Minnesota Department of Natural Resources

December 16, 2009

RE: Draft Site Permit for the 20 Megawatt Large Wind Energy Conversion System, West Stevens Wind
(PUC Docket Number: IP-6824/WS-09-830)

West Central trail Blazers Snowmobile Trail

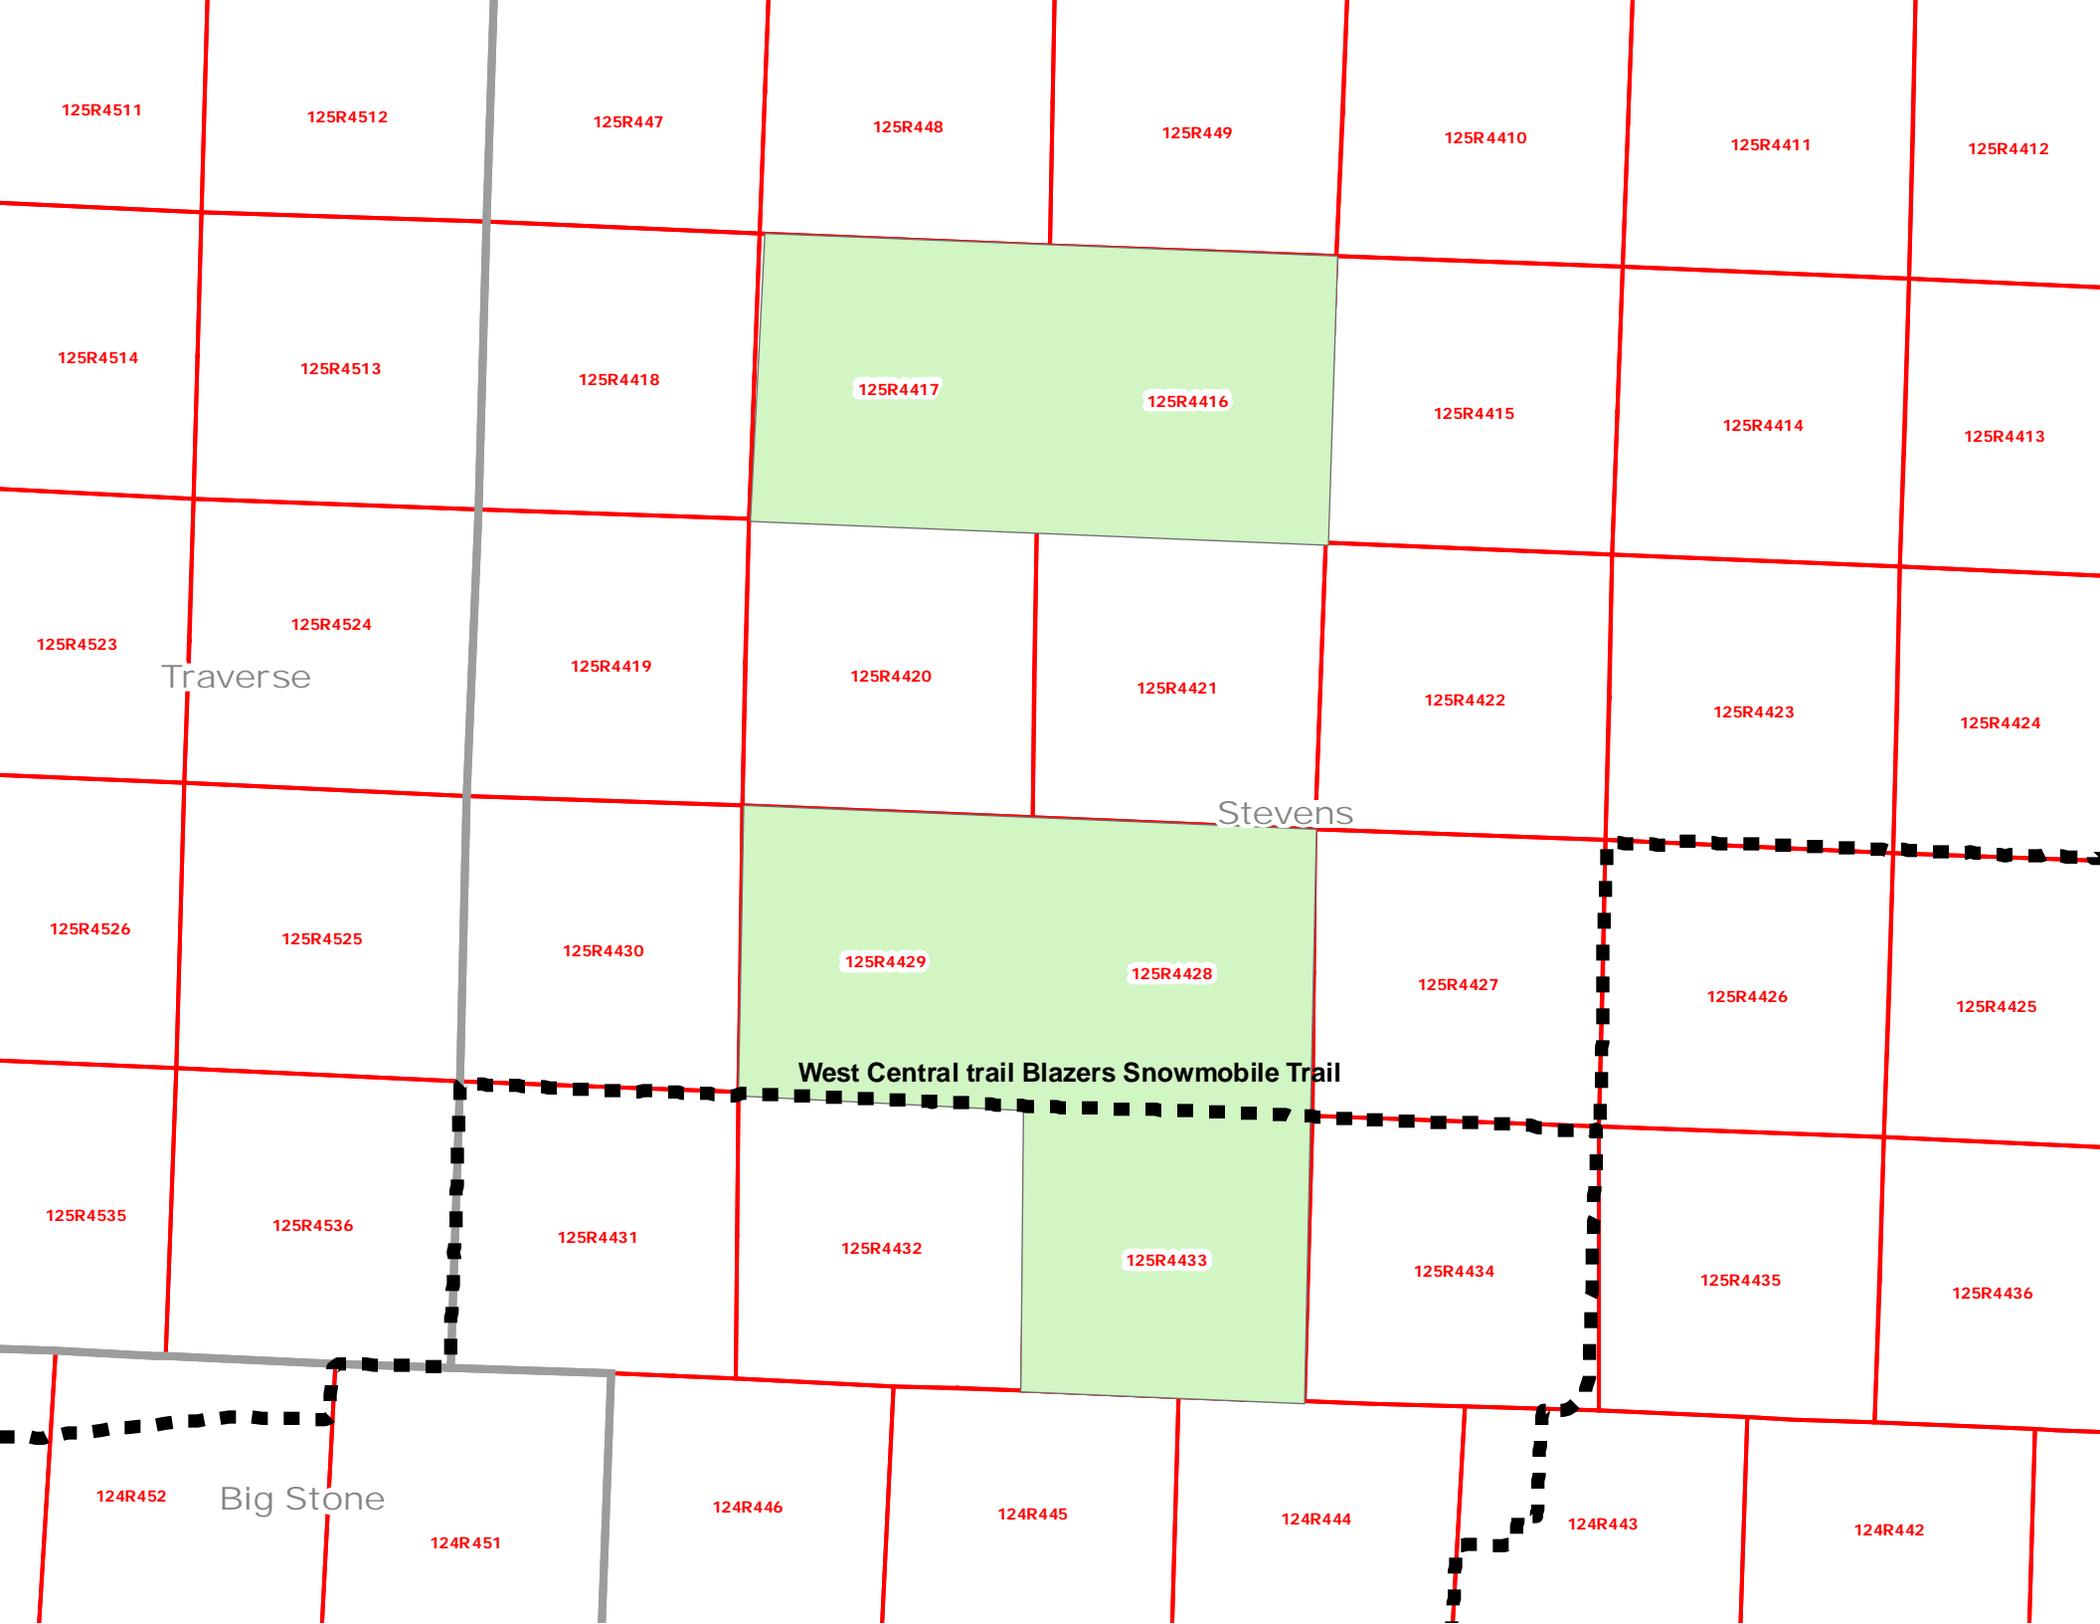
The Office of Energy Security response to DNR recommendations, included with the draft site permit, regarding an appropriate turbine setback from the West Central Trail Blazers Snowmobile Trail, noted the need for a map and further explanation of safety concerns. A map is enclosed showing the location of the West Central Trail Blazers Snowmobile Trail in relation to sections where turbines are proposed to be located. These sections are marked green. Trail maps can also be accessed at the DNR website through the "Data Deli". The webpage for snowmobile trails is: <http://deli.dnr.state.mn.us/metadata.html?id=L390002190202>.

Currently, proposed turbine placement appears to be a sufficient distance from the West Central Trail Blazers Snowmobile Trail to mitigate ice shedding or equipment failure risks. However, it is recommended that the permit include a requirement for at least a 250 foot setback from the snowmobile trail. Please also contact the DNR regarding any changes in the turbine layout that result in a turbine being located closer to the West Central Trail Blazers Snowmobile Trail than is currently proposed.
